Work Order ID 154582

Item ID: D209-669-043 Accept *N900040100* Setup Start *NS1*
Revision ID: Stop *NS2*
Item Name: AH-1F/P/S Replacement Skidtube with Standard Wearplates, Fits LH or RH
Start Date: 12/19/2016 Start Qty: 1.00 *1* Cust Item ID:
Required Date: 1/5/2017 Req'd Qty: 1.00 *1* Customer:
Reference:

DRAWING NO. D2906	TITLE AH-1 (209) SKIDTUBE ASSEMBLY	REV. B	DART AEROSPACE LTD ENGINEERING ORDER		D.E.O. NO. D2906-B-1	SHEET NO. SHEET 1 OF 1	SCALE NTS
DRAWN A.P.	CHECKED <i>[Signature]</i>	MFG. APPR. <i>E</i>	APPROVED <i>[Signature]</i>		DE APPR. <i>[Signature]</i>		
DATE 12.05.28	DATE 12.05.28	DATE 12.05.31	DATE 12.05.31		DATE 12.05.31

CHANGE ALL C'BORED WELDED CROSSBOLT SPACERS TO SWAGED SPACERS

SECTION C-C A2-2
NOT TO SCALE A2-3

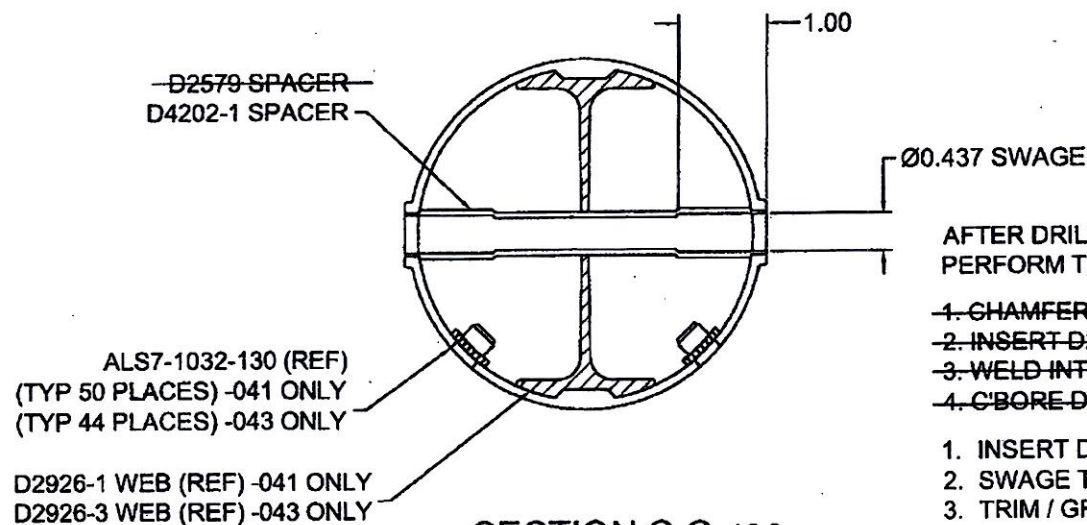
SECTION C-C ON SHEETS 2 & 3 ARE AMENDED AS FOLLOWS FOR ALL HOLES THAT WERE ORIGINALLY C'BORED:

1. CHAMFER HOLE 0.050 X 45°
2. INSERT D2579 SPACER (20 PLACES)
3. WELD INTO PLACE AND GRIND FLUSH
4. C'BORE D2579 SPACER TO Ø0.437 X 1.00 DEEP

1. INSERT D4202-1 SPACER, 22 PL (-041) OR 19 PL (-043)
2. SWAGE TO Ø0.437 X 1.00 DEEP PER QSI 002
3. TRIM / GRIND FLUSH PER QSI 002
